Reliability Analysis Update

Transmission Expansion Advisory Committee

May 9, 2023

Changes to Existing Projects

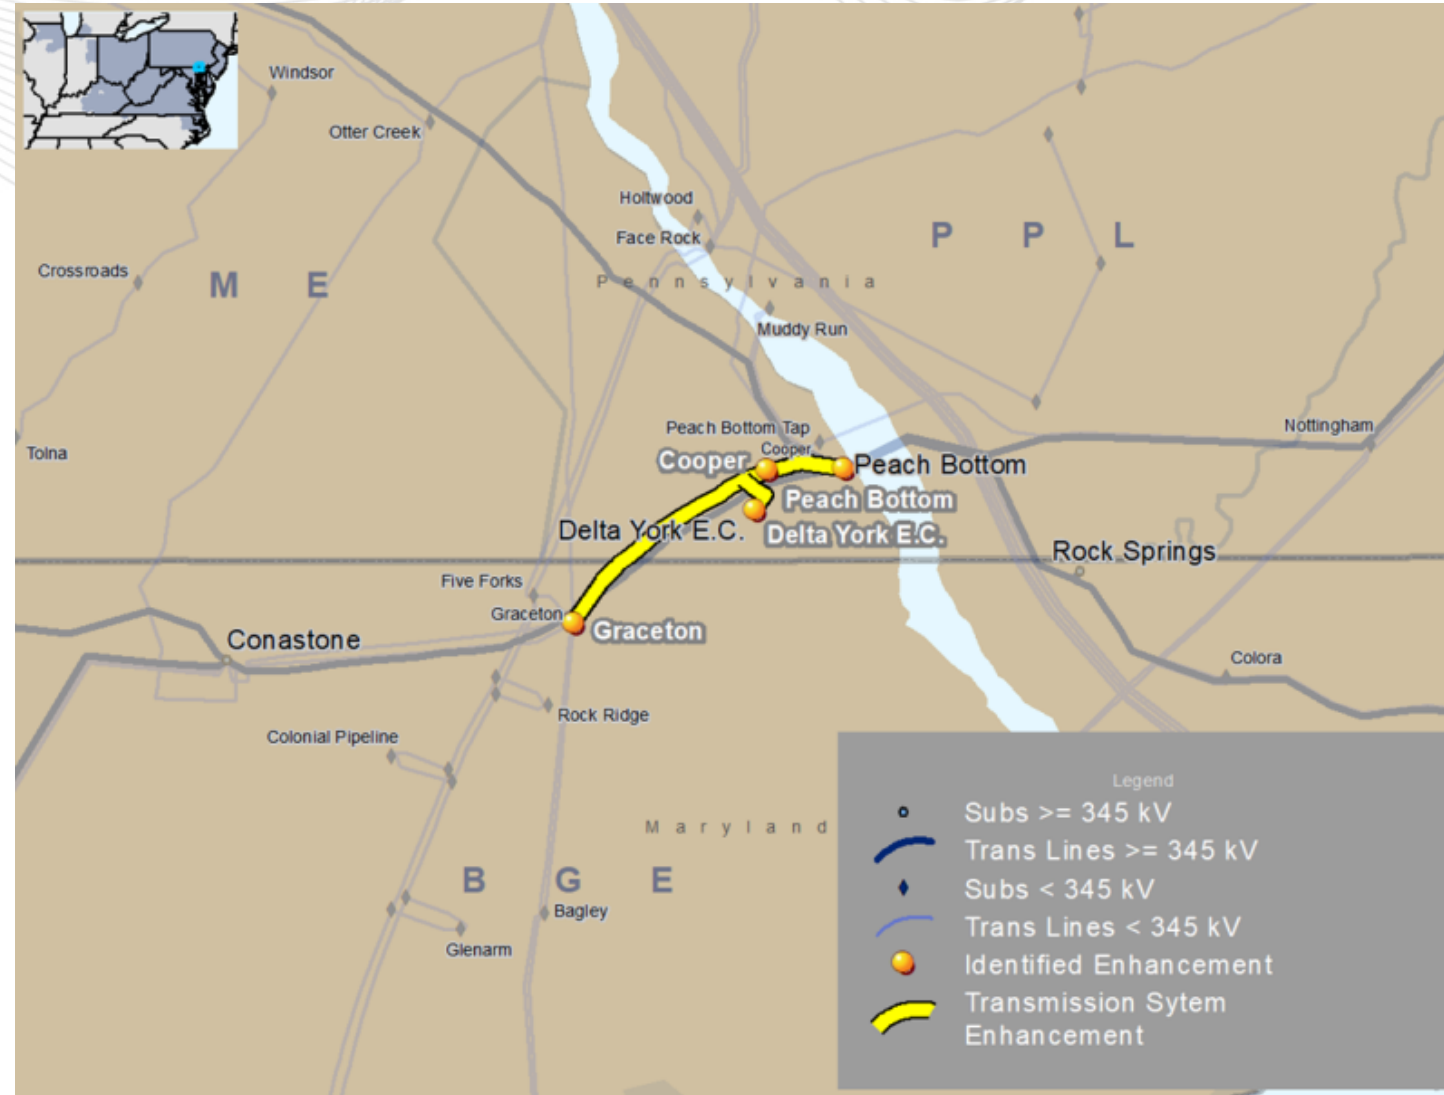
- Build a new North Delta-Graceton 230 kV line by rebuilding ~~6.07~~ **6.26 miles** of the existing Cooper-Graceton 230 kV line to double circuit. **Cooper-Graceton is jointly owned by PECO & BGE. This subproject is for PECO's portion of the line rebuild which is 4.1 miles.** (b3737.48) – PECO - ~~\$28.74 M~~ **\$18.82 M**

- **Build a new North Delta-Graceton 230 kV line by rebuilding 6.26 miles of the existing Cooper-Graceton 230 kV line to double circuit. Cooper-Graceton is jointly owned by PECO & BGE. This subproject is for BGE's portion of the line rebuild which is 2.16 miles. (b3737.56) - \$9.92 M**

- ~~Replace four 63 kA circuit breakers “205”, “235”, “225” and “255” at Peach Bottom 500 kV with 80 kA (b3737.51) – PECO – \$5.6 M~~
- Replace one 63 kA circuit breaker “B4” at Conastone 230 kV with 80 kA (b3737.52) – BGE - \$1.3 M

Estimated Cost (b3737.46-52): ~~\$116.58 M~~ **\$110.98 M**
